2.0 SITE CHARACTERISTICS

Chapter 2, "Site Characteristics," of the Fermi 3 Combined Operating License (COL) Final Safety Analysis Report (FSAR) addresses the geological, seismological, hydrological, and meteorological characteristics of the site and vicinity, in conjunction with present and projected population distribution and land use, and site activities and controls.

Figure 2.4.3-1. Hourly distribution of the probable maximum precipitation for the Swan Creek Watershed.

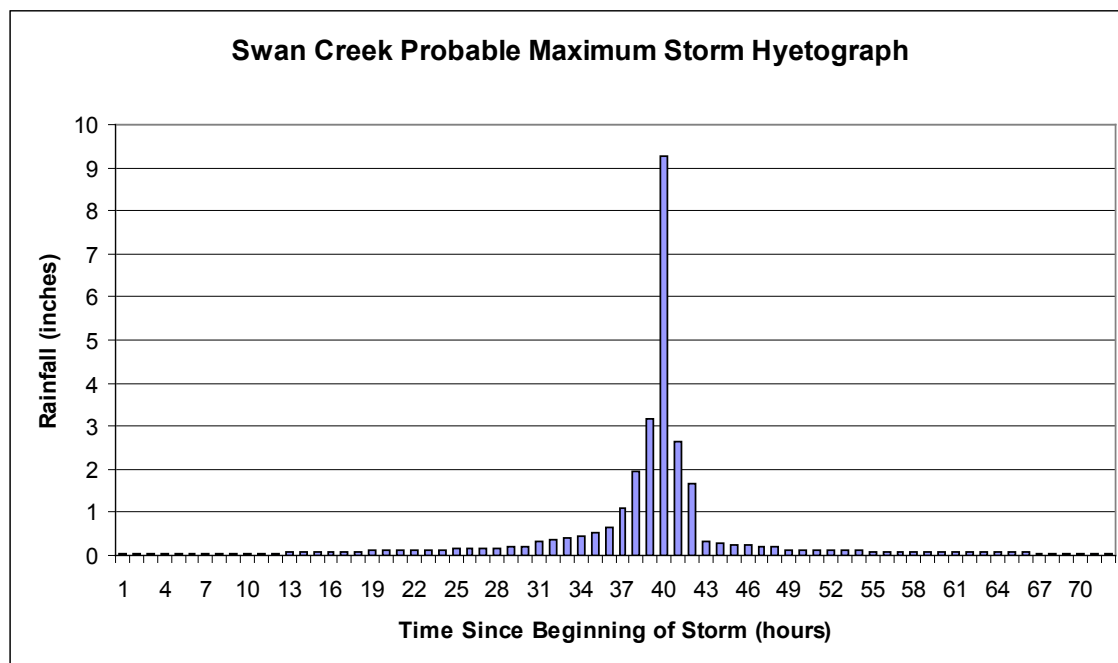
The staff also checked the applicant's calculation of PMP with snowmelt, as submitted in the response to **RAI 2.4.2-1** (ML092790561, dated September 30, 2009). First, the applicant used the USACE HMR-52 software to define the PMP, similar to the method described by the staff, above. Second, the applicant calculated snowmelt for each time interval during the storm. The values for rainfall and snowmelt were combined for each time interval to become a total value of effective precipitation on the watershed.

The applicant's input and output values for the HMR-52 program were very similar to the staff's. Both the staff and the applicant used a value of 0.302 for the ratio of the 1 to 6 hour storm. The staff found a maximum storm orientation of 309 degrees and the applicant found a maximum storm orientation of 311 degrees. The depth-area-duration curves used by the applicant were slightly larger overall than those used by the staff, and thus the applicant's analysis was more conservative. Therefore, the applicant's input values were found to be acceptable. The applicant calculated a PMP of 28.9 from the HMR-52 software, the same value determined by the staff's calculation.

Figure 2.4.3-2. Hourly distribution of the probable maximum storm with snowmelt for the Swan Creek Watershed.

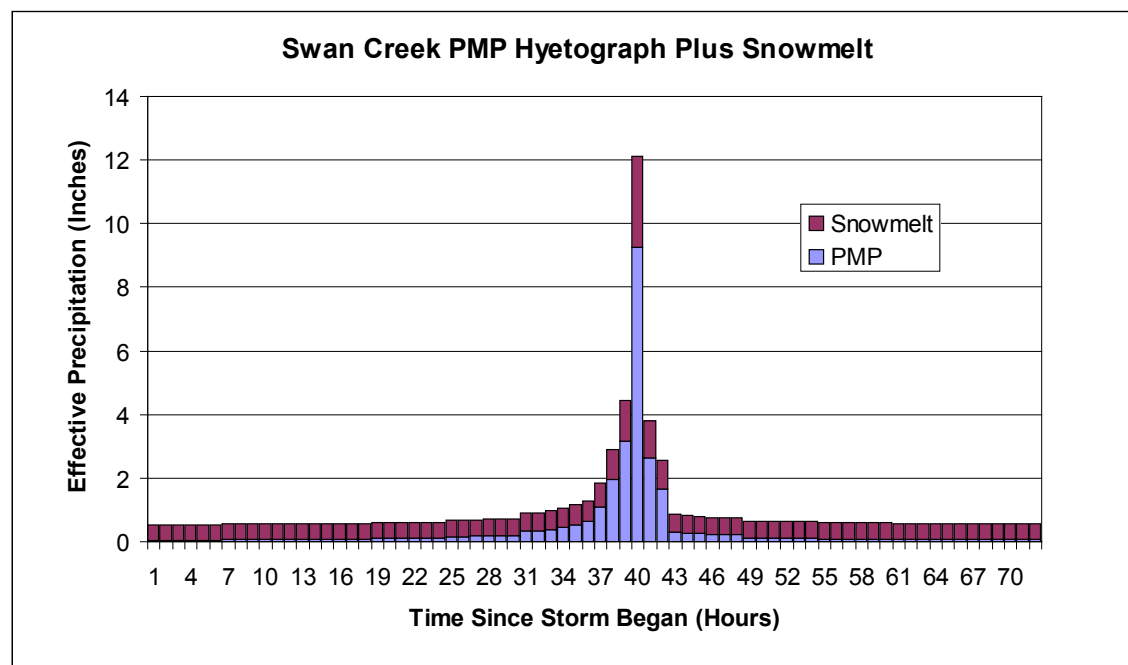
The applicant calculated snowmelt for each time step using equation 5-19 from the USACE manual *Runoff from Snowmelt* (USACE, 1998). A full discussion of the verification of the snowmelt calculations is presented in Section 2.4.2.4.3 above. The staff verified the results of

the snowmelt calculations and independently calculated the same cumulative rain and snowmelt total of 70.3 inches over 72-hours.

The staff-calculated PMP with snowmelt for the Swan Creek Watershed shown in Figure 2.4.3-1 above can be directly compared to Figure 2.4-XX-3 submitted by the applicant with the response to **RAI 2.4.2-1** (ML092790561, dated September 30, 2009). The staff finds the applicant's calculation of PMP with snowmelt to be acceptable, because the applicant's PMP is the same as the value calculated by the staff.

Figure 2.4.3-3. Probable maximum flood runoff using HEC-HMS 3.1.0 rainfall-runoff model.

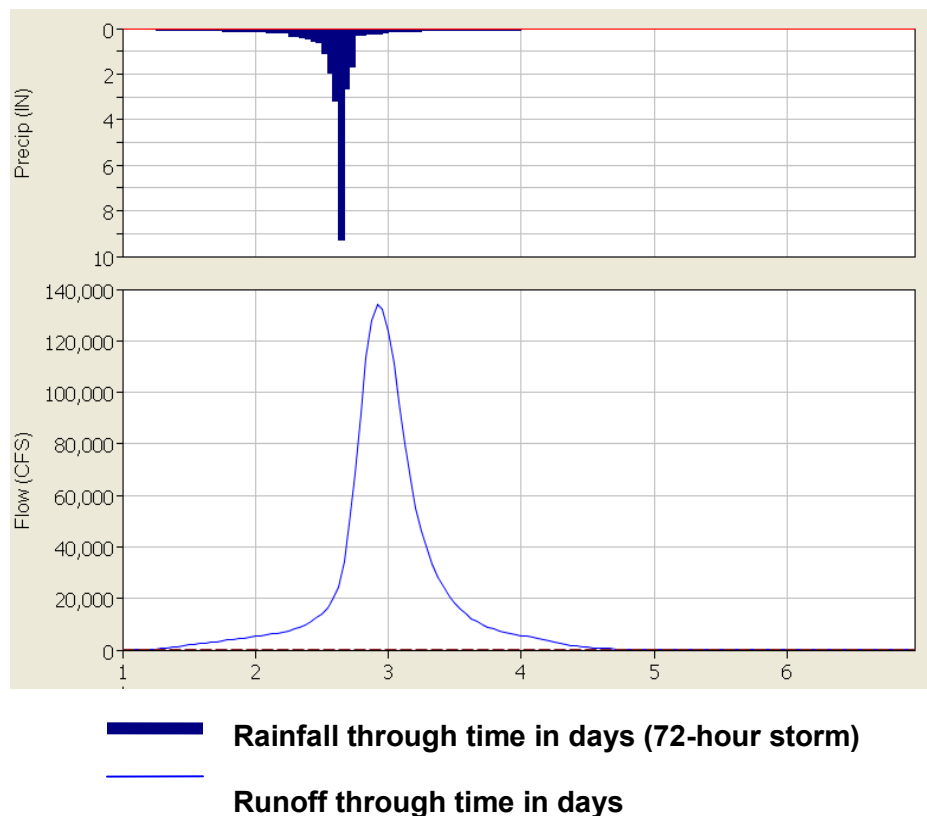
Staff developed flood hydrographs (Figure 2.4.3-3) based on the parameters discussed above. By developing an independent hydrograph, Figure 2.4.3-3 can be directly compared with Figure 2.4-219 of the FSAR to examine the PMF runoff calculated by the staff versus the PMF runoff calculated by the applicant.

Figure 2.4.3-4. Probable maximum flood with snowmelt runoff using HEC-HMS 3.1.0 rainfall-runoff model.

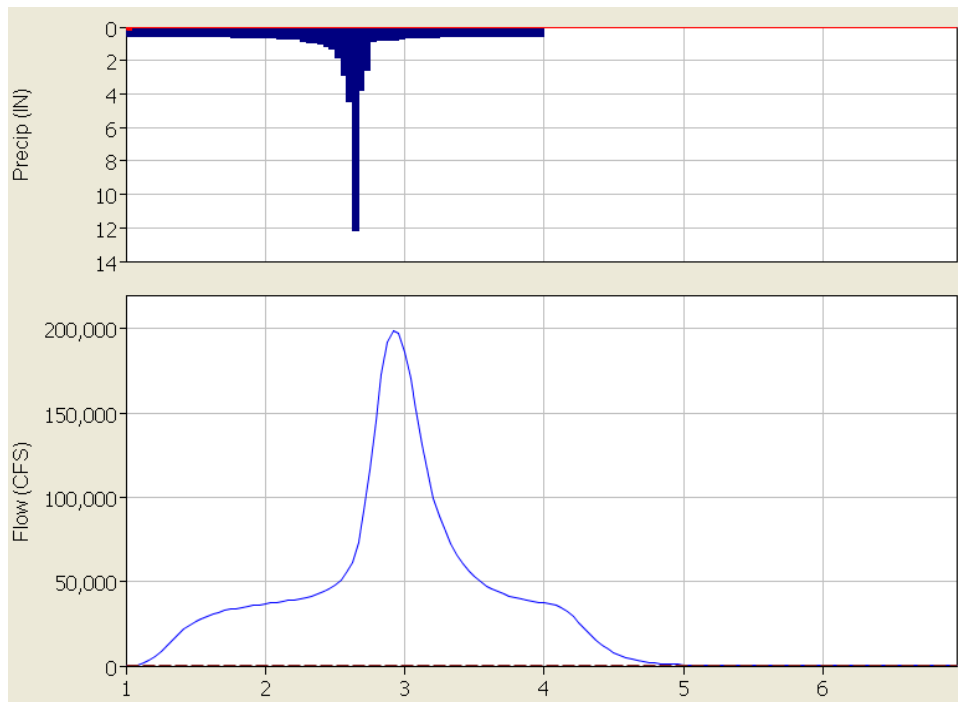
NRC staff independently calculated the PMF with snowmelt for Swan Creek and obtained a value of 199,000 cfs, which is approximately 18 percent higher than the value presented in the response to **RAI 2.4.2-1** (ML092790561, dated September 30, 2009).

Staff independently developed a flood hydrograph that include snowmelt (Figure 2.4.3-4) The staff hydrograph in Figure 2.4.3-4 can be directly compared with Figure 2.4-2-XX-4 of the response to **RAI 2.4.2-1** (ML092790561, dated September 30, 2009) to examine the runoff from the PMF plus snowmelt calculated by the staff versus the PMF plus snowmelt runoff calculated by the applicant.

Figure 2.4.5-1. Wave height and Bathymetry of the western Lake Erie derived by STWAVE.

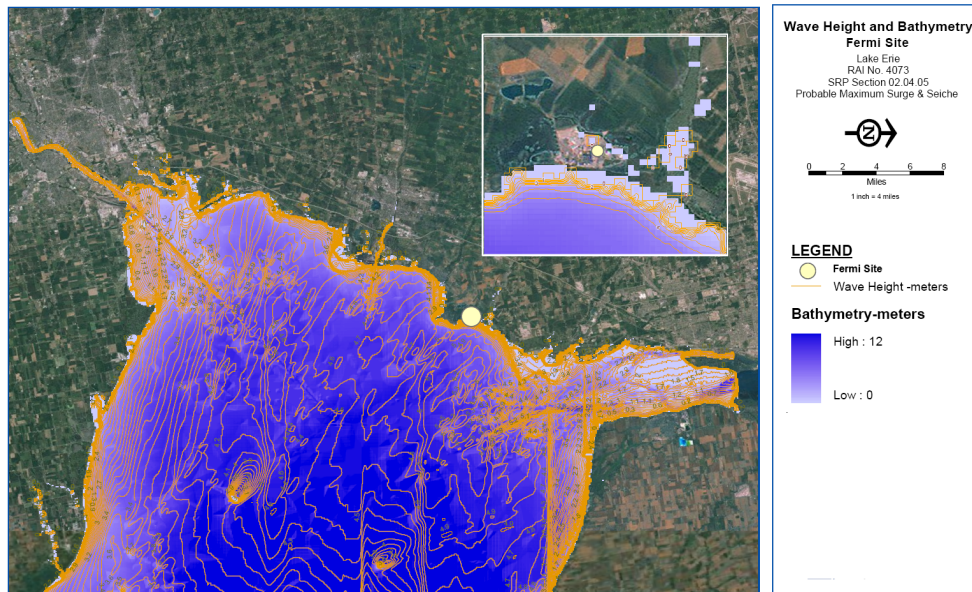
In the responses to **RAI 2.4.5-3** and **RAI 2.4.5-7**, the staff verified the results derived by the applicant by modeling the entire area of Lake Erie using the model grid of 100 m using STWAVE. The resulting distribution of wave heights is shown in Figure 2.4.5-1.

Figure 2.4.5-2. STWAVE data points near Fermi 3.

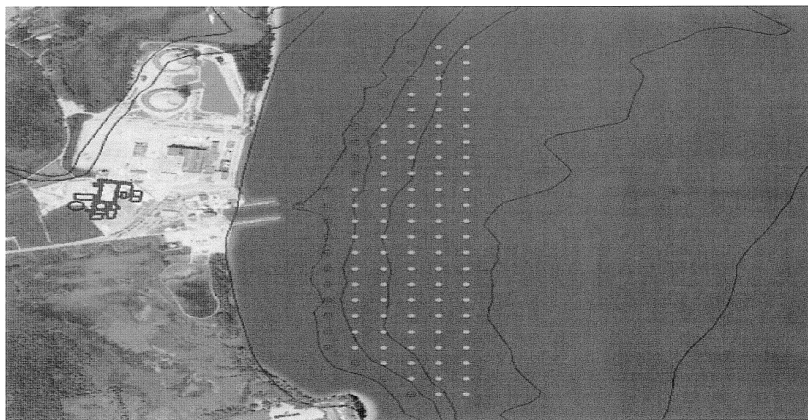
The STWAVE data points near the Fermi 3 are shown in Figure 2.4.5-2. The wave periods at all these points are 11.1 seconds. The wave height at the point near Fermi 3 is 3.7 m. The wave parameters selected by the applicant using STWAVE are conservative based on the staff's independent verification using additional data received in RAI responses. These parameters, including wave period and distribution of wave height, were used for further calculation of wave action across the shore.

Figure 2.4.5-3. Cross Section from the STWAVE point to the Fermi 3 safety-related structure.

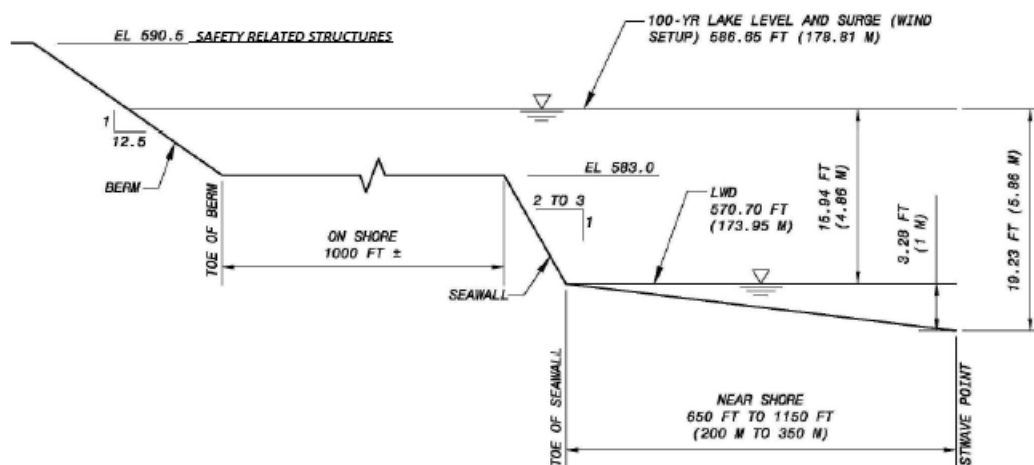
and still water depth. The applicant, however, did not provide a discussion on the change in total water depth due to the wave set-up across the shore. So, the staff requested that the applicant use graphs to illustrate the shore profile (from an STWAVE point to the Fermi 3 safety structures), wave characteristics across the shore (maximum still water level, wave length, wave height, breaking wave, run-up, etc.), their relationship, and quantitative information that supports conclusion of no impact to Fermi 3 safety structures. **RAI 2.4.5-8** (ML092870355, dated January 29, 2010) was issued to the applicant.

In response to **RAI 2.4.5-8** (ML092870355, dated January 29, 2010), the applicant provided the information regarding the cross section from the STWAVE point to the Fermi 3 safety structures and the calculated the wave characteristics across the shore (Figure 2.4.5-3). The staff verified that all information is correct by checking the cross section data to that information used in the model. The shore profile data were used in the model input for the calculation of the breaking wave and wave run-up.

Figure 2.4.5-4. Characteristics of breaking waves at the toes of the seawall and berm (vertical exaggeration, ~10:1; Elevation in Plant Datum).

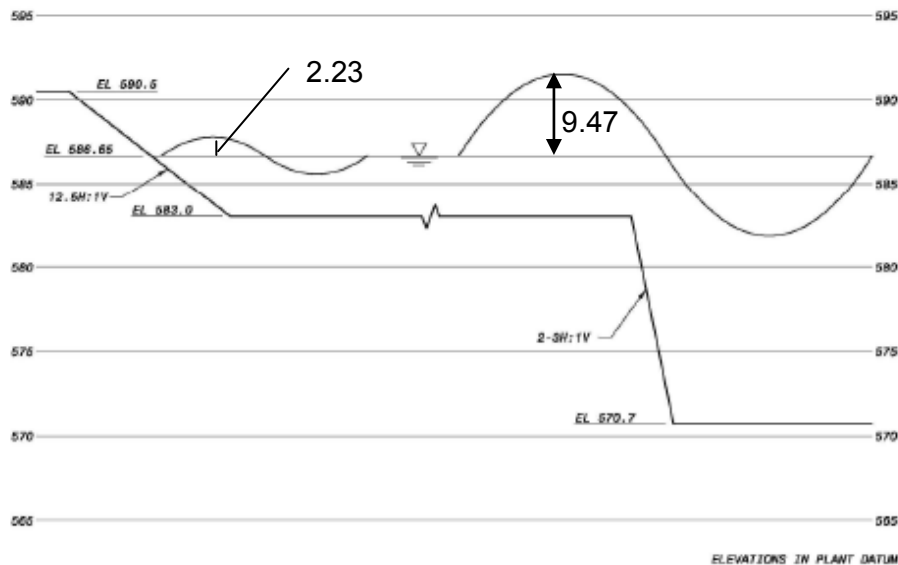
The breaking wave was calculated using the ACES model at two points: the toe of seawall at a water depth of 15.9 ft and the toe of the berm at a depth of 3.65 ft. The wave characteristics were predicted by the model as shown in Figure 2.4.5-4, assuming a constant wave period as incoming wave at 11.1 second. The staff confirms that this assumption is conservative because a possible decreasing period of waves through the shore profile would result in a smaller wave length and height. In response to **RAI 2.4.5-8** (ML092870355, dated January 29, 2010), the applicant also corrected wave heights in the Table 2.4.224. Based on a breaking wave calculated at the toe of the berm, the breaking wave developed on the probable maximum surge (585.4 ft NAVD 88) resulted in a water level of 587.6 ft NAVD 88, which is 1.7 ft below the nominal Fermi 3 plant grade of safety-related structures (589.3 ft NAVD 88). Thus, no breaking waves would impact safety-related structures.
